DATE: DECEMBER 6, 1996
MODEL YEAR: 1995, 1996, and 1997
MODELS AFFECTED: UD1800/UD2300/UD2600/UD3000
BULLETIN #: SC - 216
FILE AT THE END OF THE ELECTRICAL SECTION IN THE TECHNICAL BULLETIN BINDER

VOLUNTARY SAFETY RECALL CAMPAIGN # 96V - 216

CAB FLOOR WIRING HARNESS INSULATION INSTALLATION

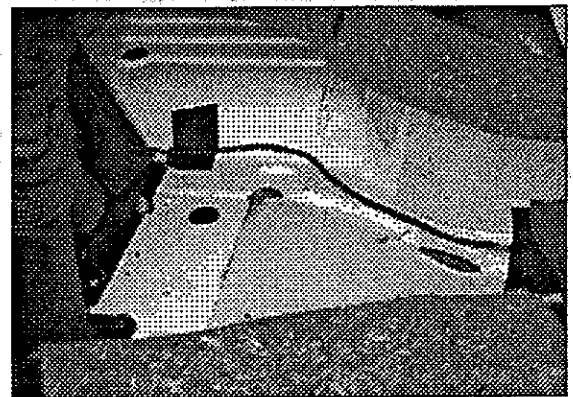
Remove the existing tapes that secure the wiring harness to the engine/floor panel.

Remove all loose dirt from around the wiring harness. Use a mild cleaning solution to remove any residual adhesive from the floor/engine panel. Allow the area to dry thoroughly before continuing.

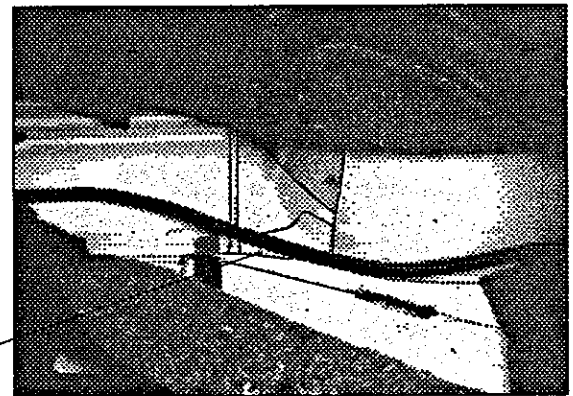
3. Install the small diameter corrugated tube over the wiring harness from the accelerator pedal to the driver's seat base. Push the tube all the way down the length of the harness between the driver's seat and the engine tunnel as far back as possible.

Note location of floor panel seam at base of shift tower.

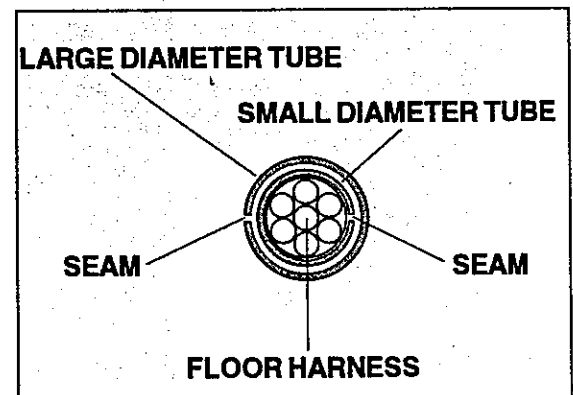
4. Install the large diameter corrugated tube over the small diameter corrugated tube with the seam 180° apart from the seam of the small diameter corrugated tube, as shown in the figure on the right.

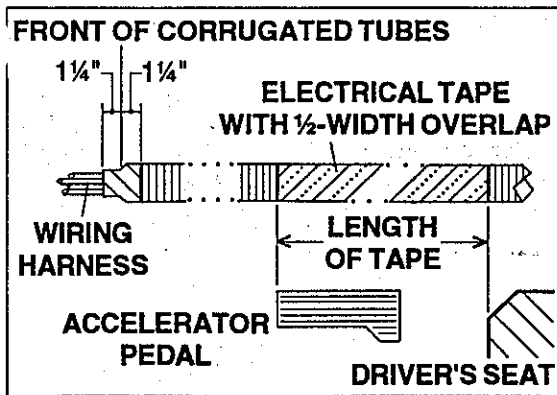
5. Secure the front of the corrugated tubes to the wiring harness with electrical tape as shown in the figure on the left.

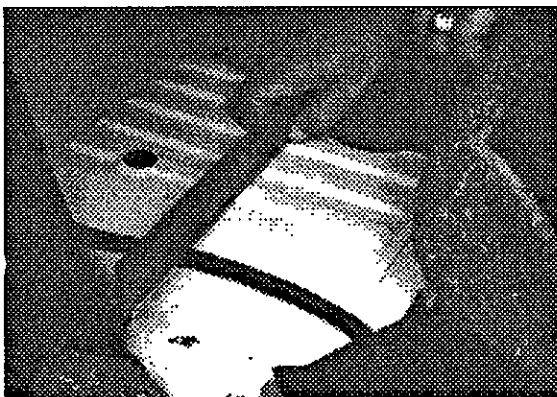
Apply another piece of square padded insulated tape over the piece previously installed at the base of the shift tower in step 6 above.

8. Lay a straight-edged ruler across the floor panel directly in front of the engine tunnel. Align the wiring harness below the edge of the ruler, as shown in the figure on the left, and secure it to the floor panel with pieces of small rectangular padded insulated tape. Permanently secure the wiring harness in place with the long rectangular piece of padded insulated tape.

9. The finished results should resemble the figure on the right.
